PEP100 — back-of-device marking placement

For JWD · all dimensions in mm · marking on the lower back (button side, opposite the camera)

APPEARANCE

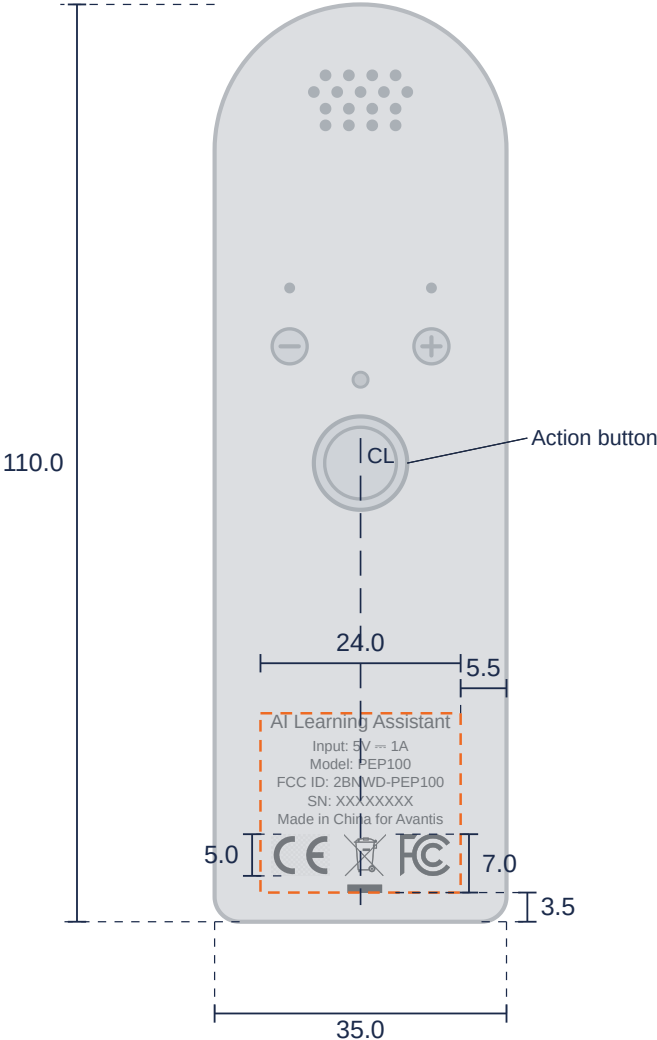
CE and WEEE marks now meet their legal minimum heights (CE 5.0 mm, WEEE bin 7.0 mm), top-aligned, with the WEEE base 3.5 mm from the bottom edge. Other changes from the lab-accepted label — **re-confirm with the lab/JWD**: product name "AI CAMERA" → "AI Learning Assistant"; "1000mAh Built-in battery" line removed (a Battery Regulation item, not LVD); applicant name added as "Made in China for Avantis". Full postal address to appear on packaging/manual. CE is accepted in Great Britain (no UKCA required for this product type). Marks use the supplied official artwork recoloured to silver (embedded raster; vector on request).
